#### SIB 11 08 21

Recall 21V-907: Exhaust Gas Recirculation (EGR) Cooler – N57T High Temperature

This Service Information Bulletin (Revision 5) replaces SI B11 08 21 dated January 2024.

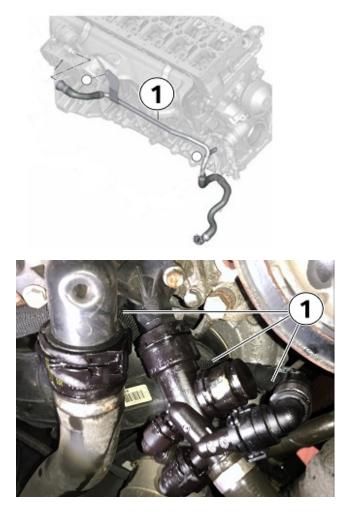
**Hint:** Record or take a photo of the following numbers on the new EGR cooler before installation (1, 2 and 3). These numbers will be required later to register the new cooler in ISTA.

- 1. Production date [YY-MM-DD]
- 2. Revision index
- 3. Serial number

• Replace the coolant pipe from the Auxiliary EGR cooler to the coolant pump distribution block (1)

• NOTE: The new coolant line P/N 11 14 7 827 410 is routed in a different location than the original line (1)
